**TOWN OF NEWBURGH
PLANNING BOARD
TECHNICAL REVIEW COMMENTS**

PROJECT NAME: RAM HOTELS
PROJECT NO.: 16-21
PROJECT LOCATION: SECTION 95, BLOCK 2, LOT 37.1
REVIEW DATE: 28 OCTOBER 2024
MEETING DATE: 7 NOVEMBER 2024
PROJECT REPRESENTATIVE: MECURIO-NORTON-TAROLLI-MARSHALL

Site Plan
for
RAM Hotels, Inc.

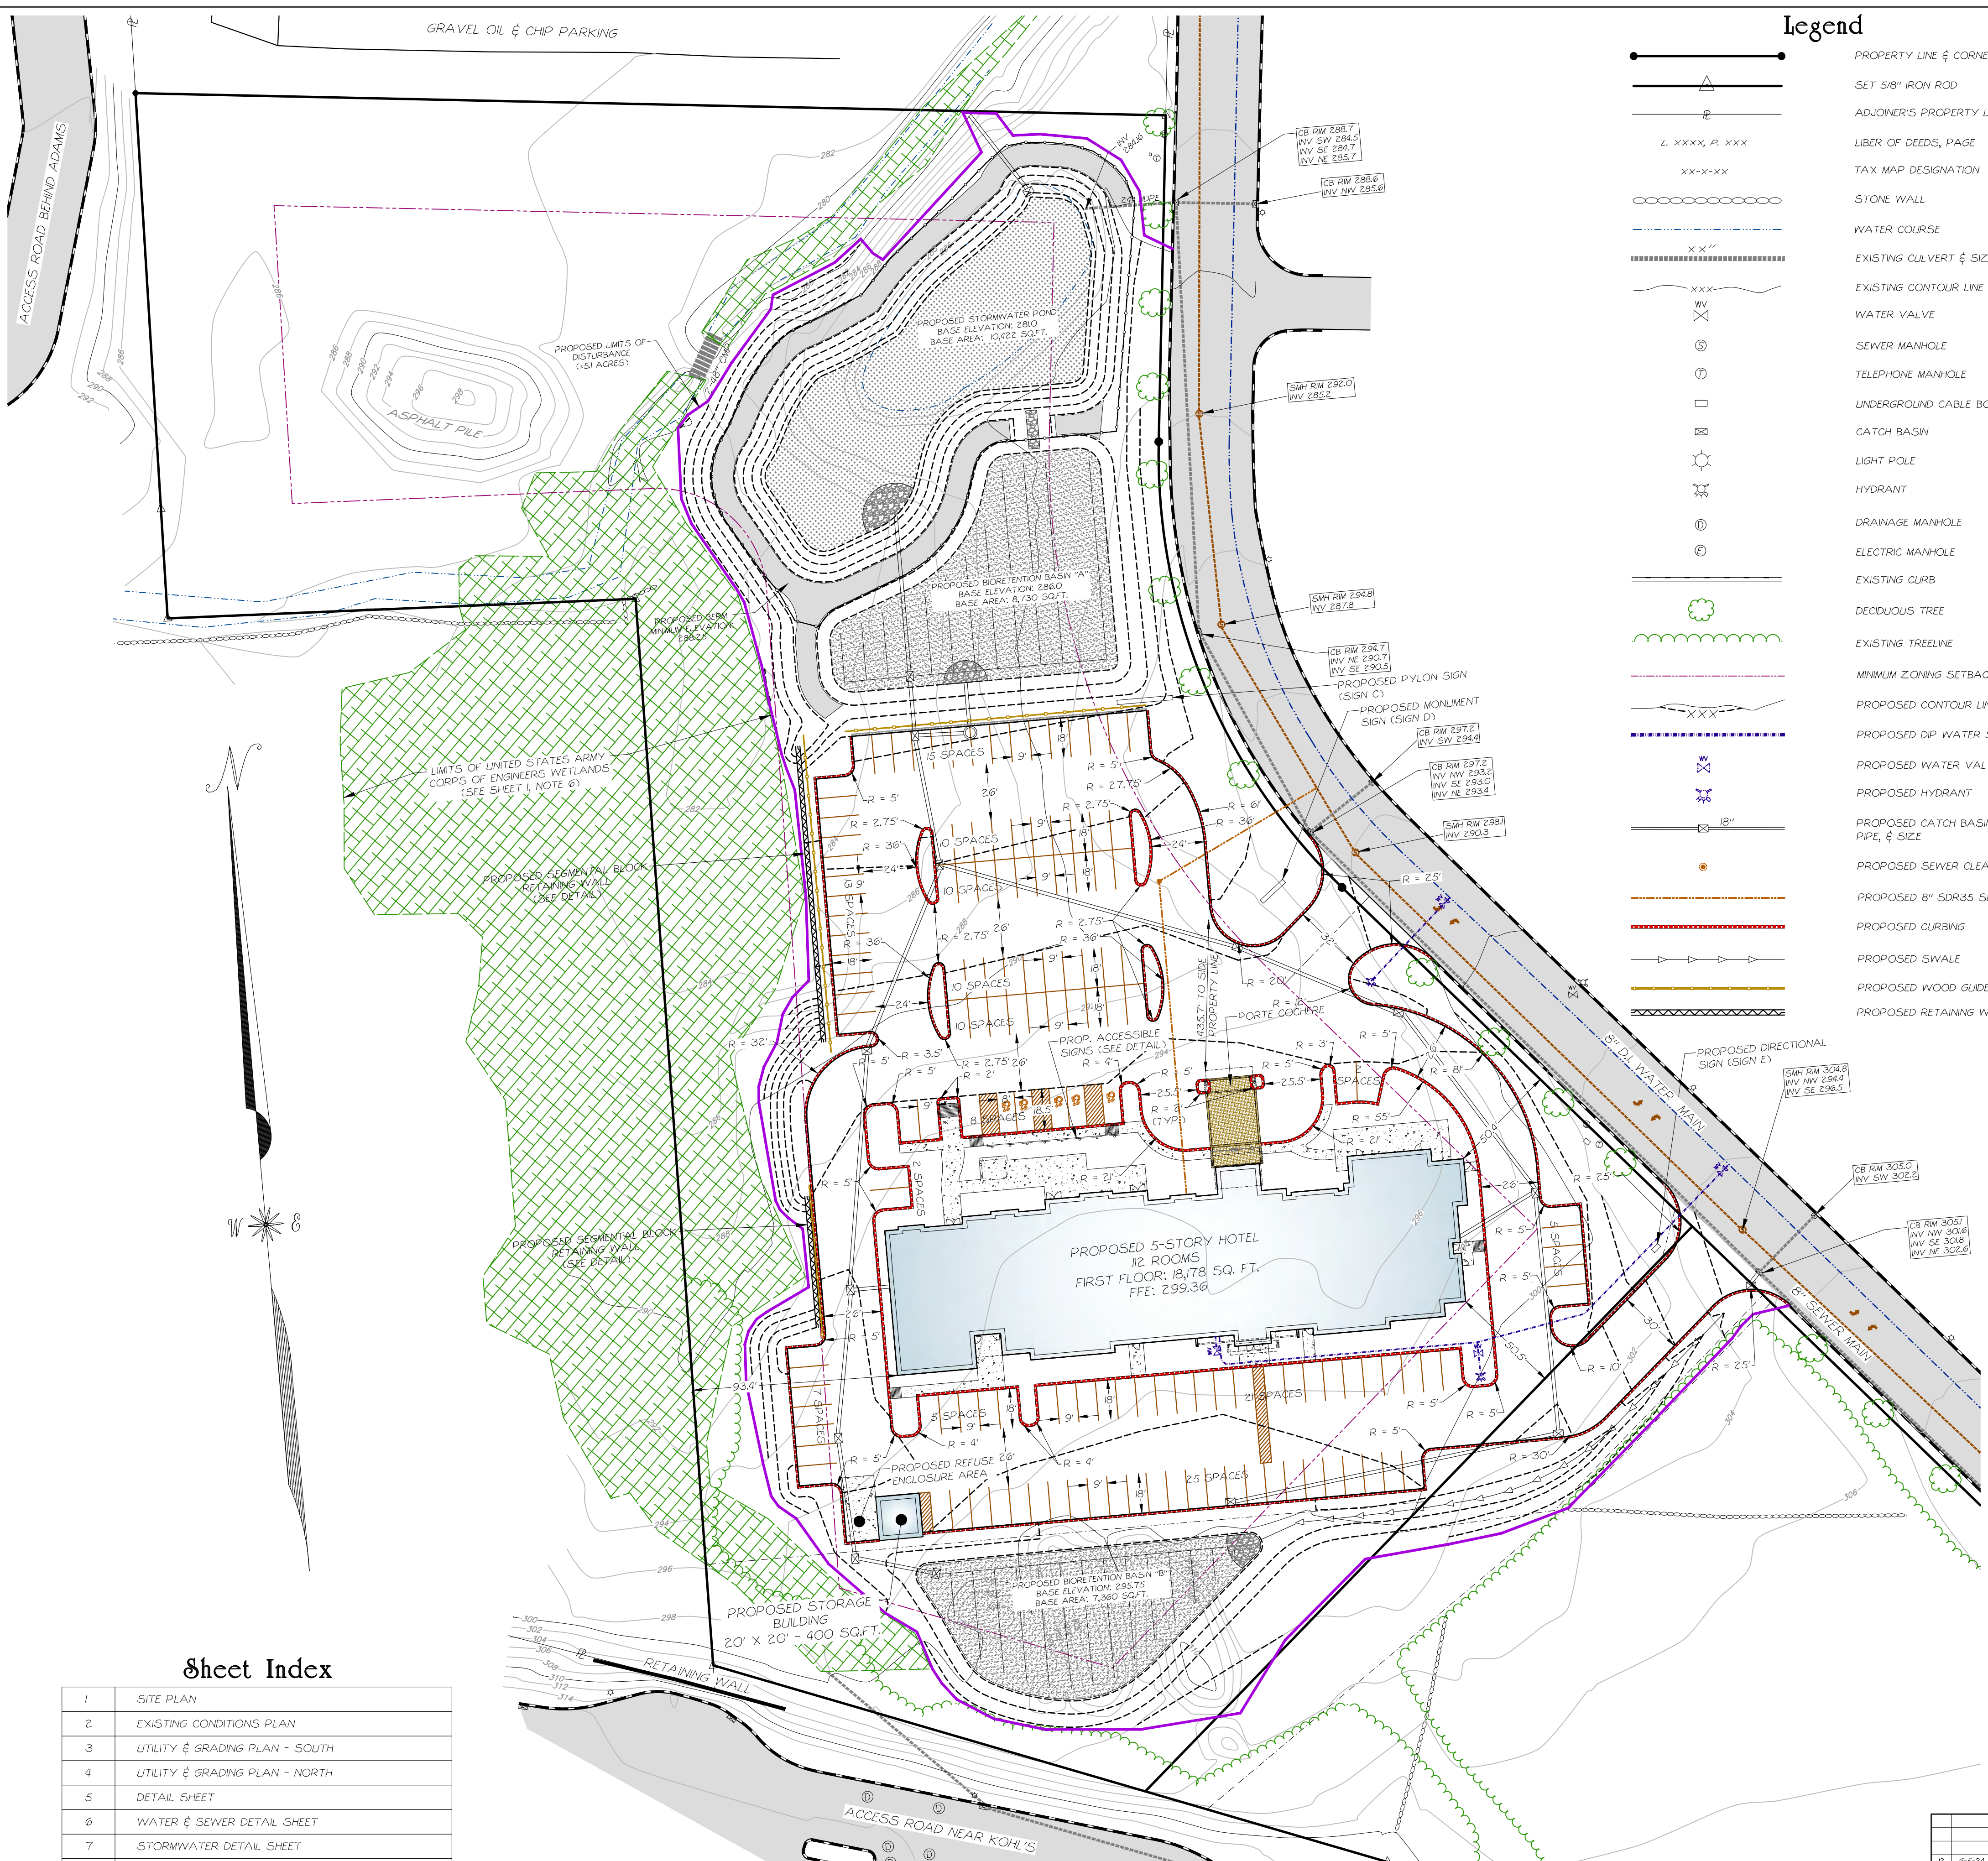
9. The project will reduce peak flows from all storm events in the post development condition .
10. The project requires 143 parking spaces. 143 parking spaces are proposed. Previous versions of the project contain land bank parking which has been removed. 143 parking spaces are required.

Bioretention Area "A" Detail
NOT TO SCALE

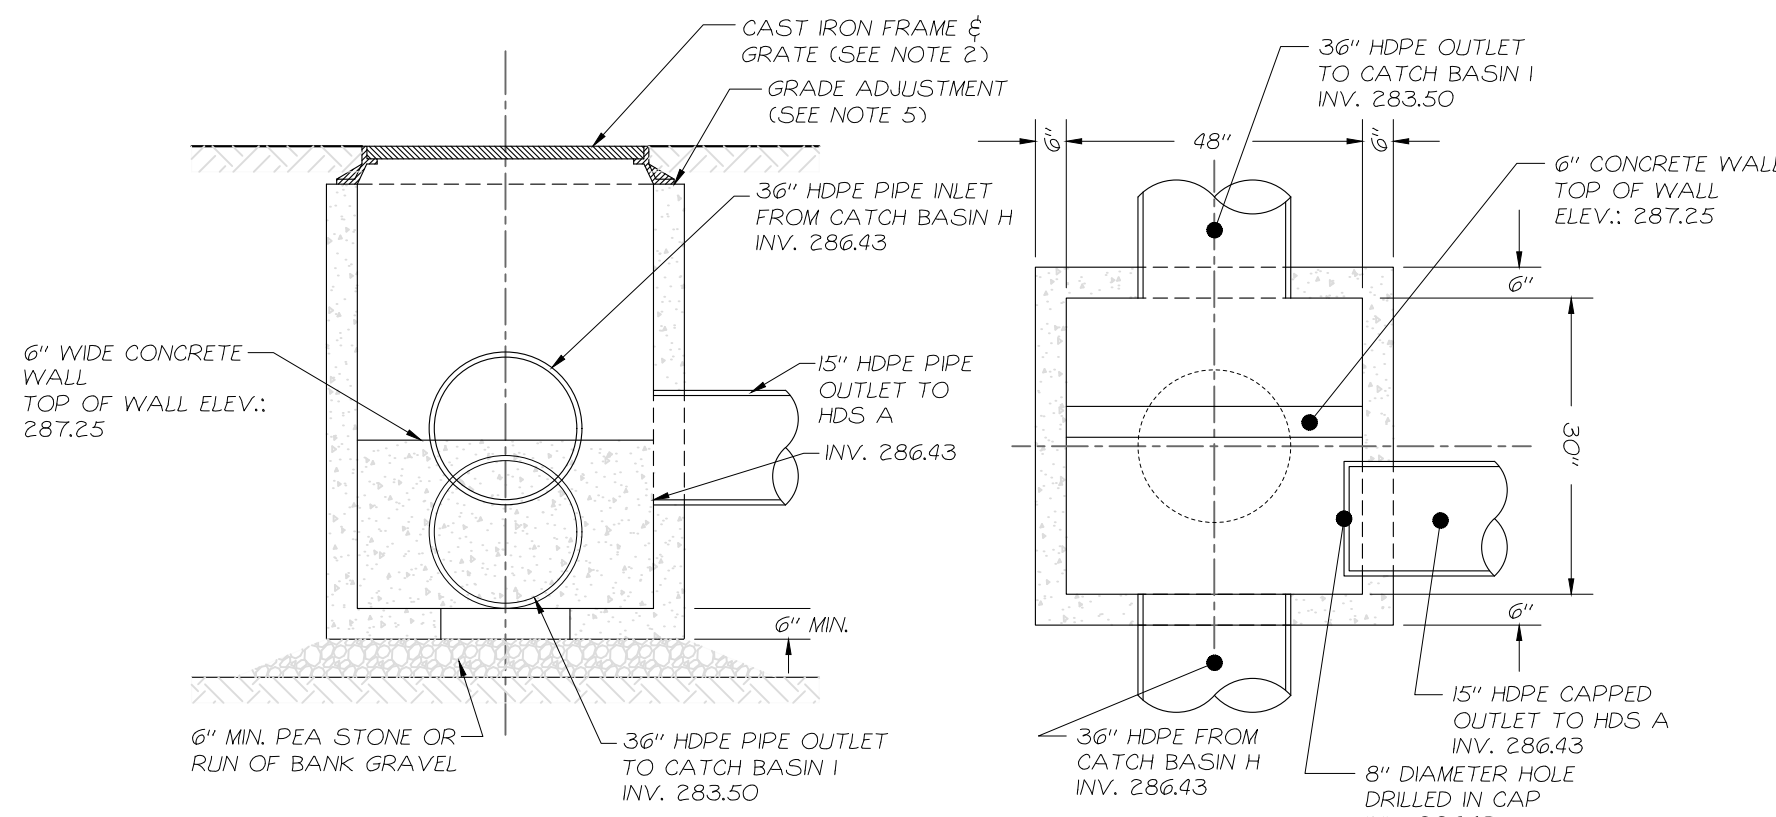
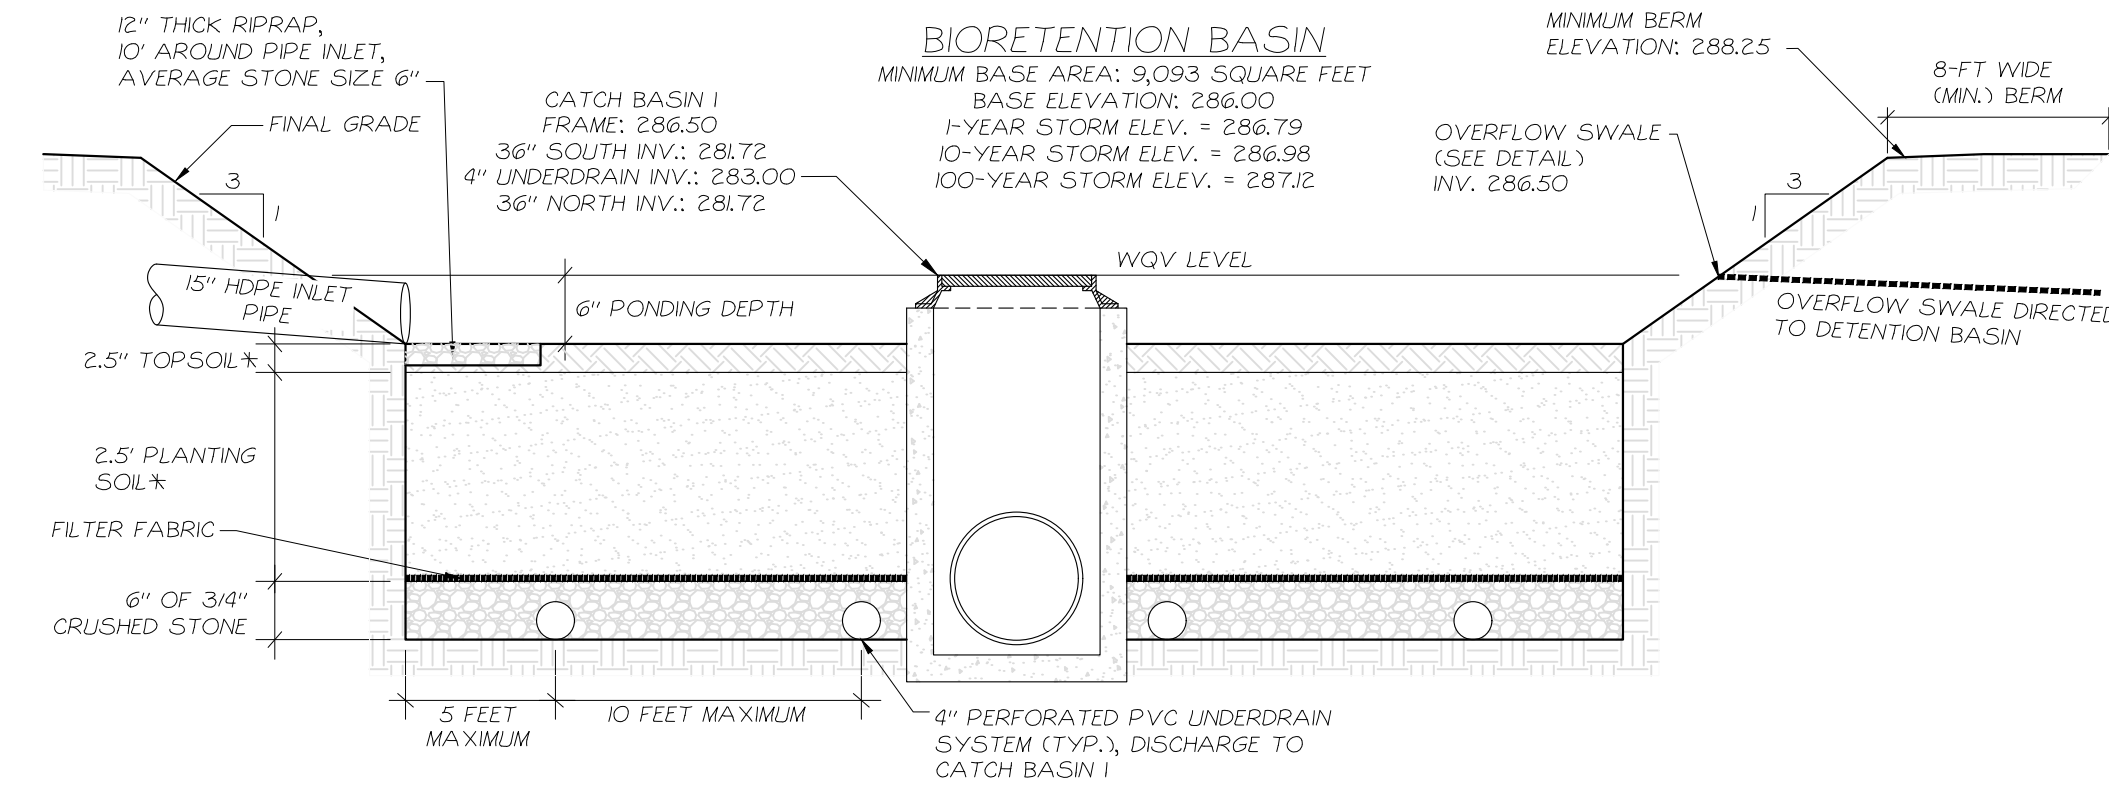
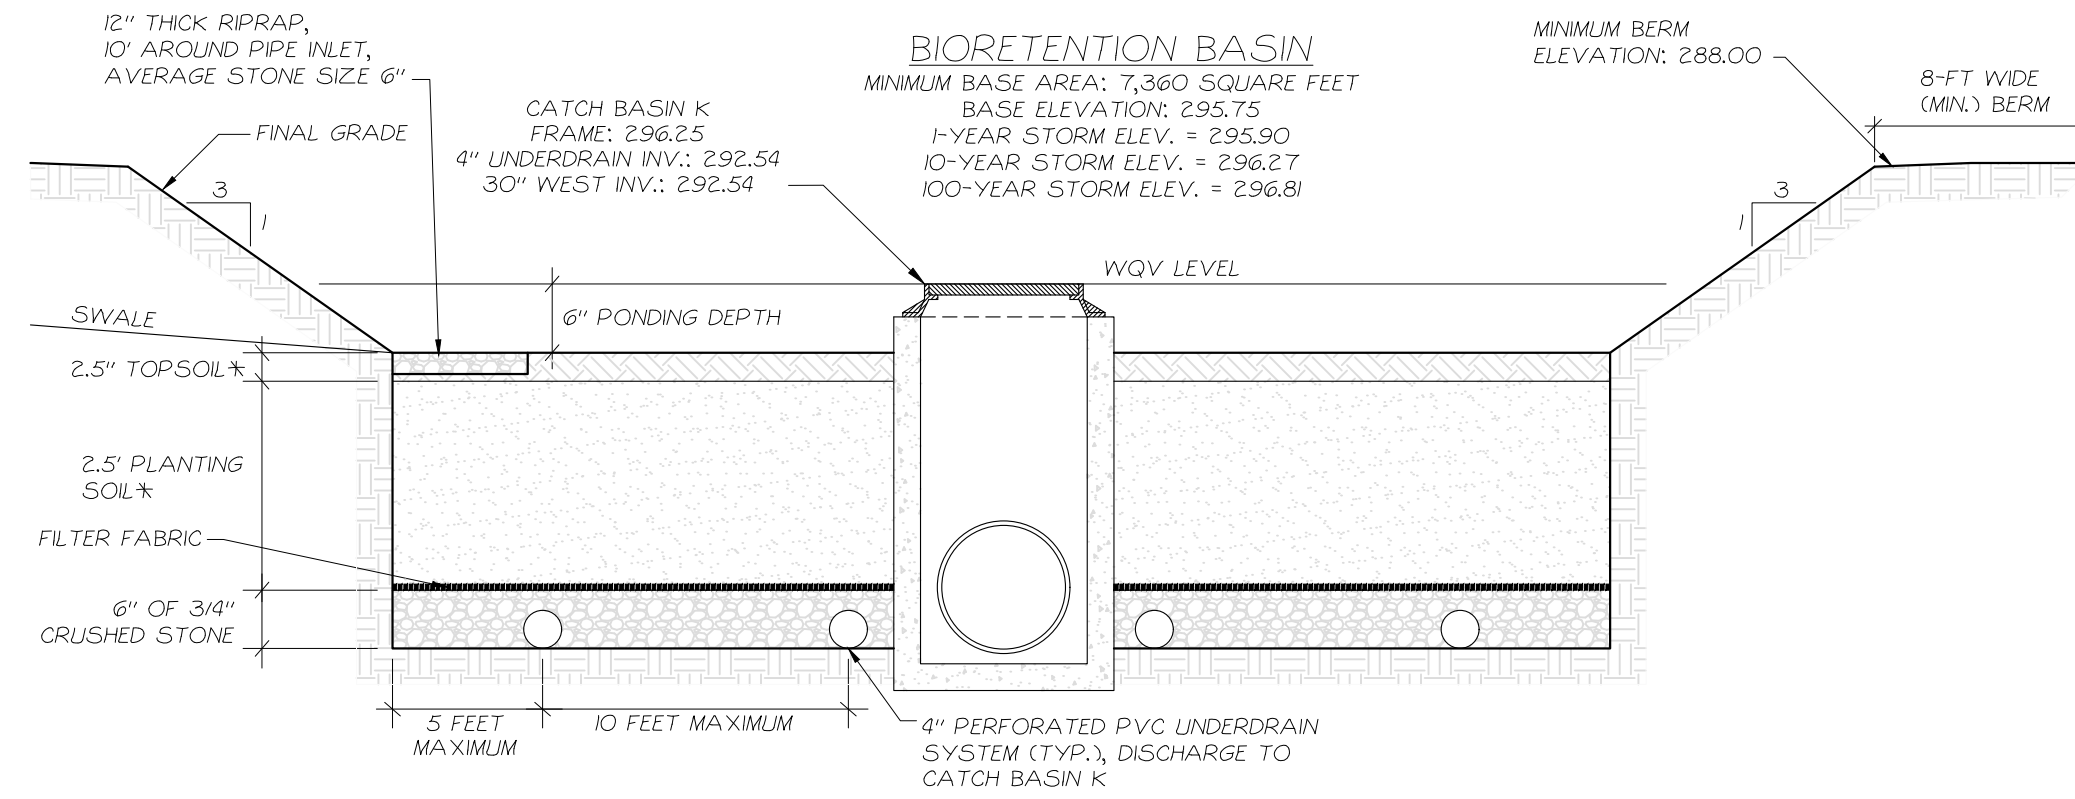
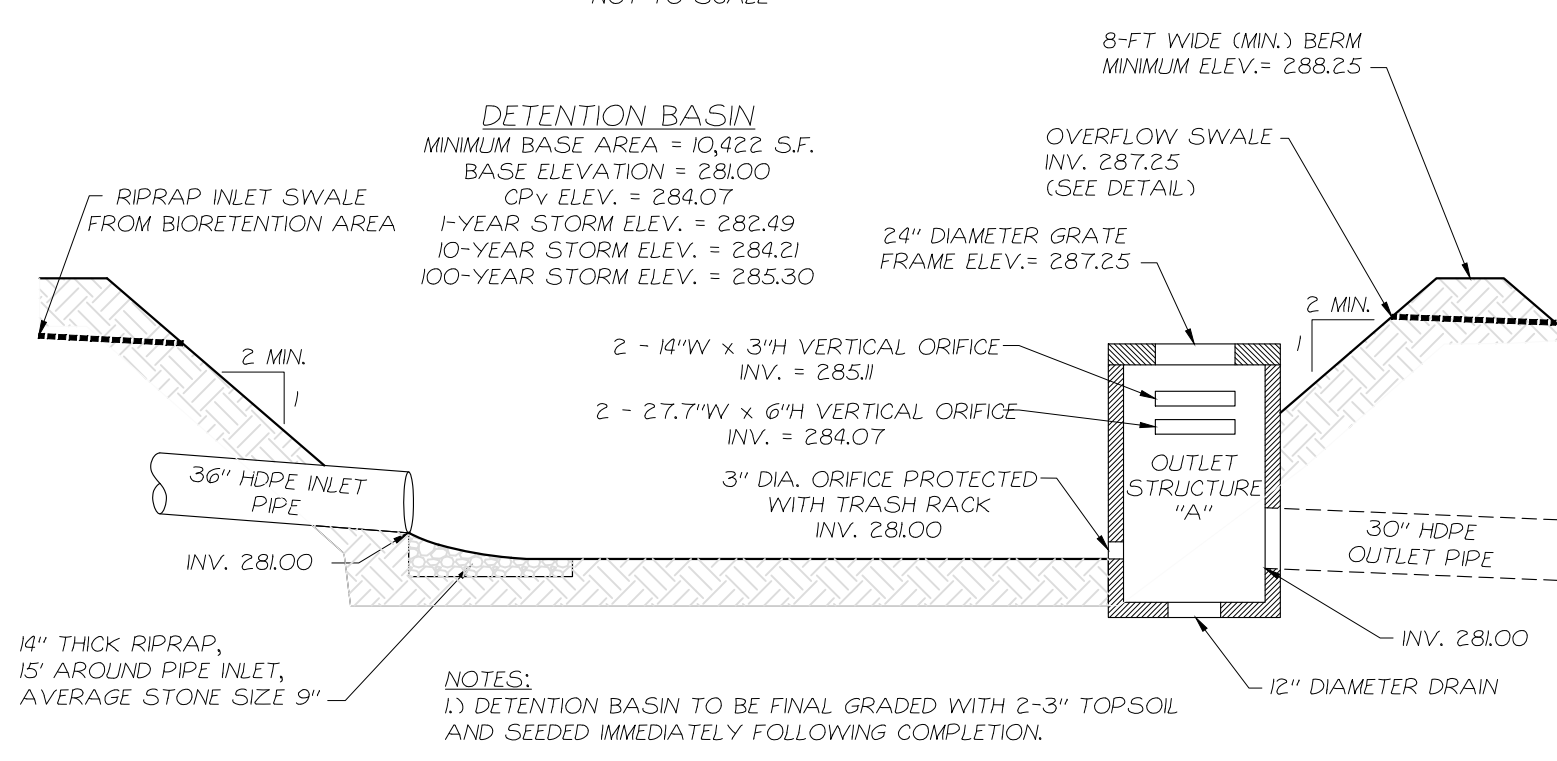
4. The project proposes two bioretention basins, hydrodynamic separator, and a stormwater quantity control facility. Pretreatment is provided in the hydrodynamic separator prior to discharge to the bioretention area A.

7. Status of the City of Newburgh acceptance letter should be confirmed.
8. The proposed stormwater facilities reduce the water quality volume by approximately 40%. Existing soils are classed D.RRV and WQV are equal to the water quality volume required of .250 acre feet.
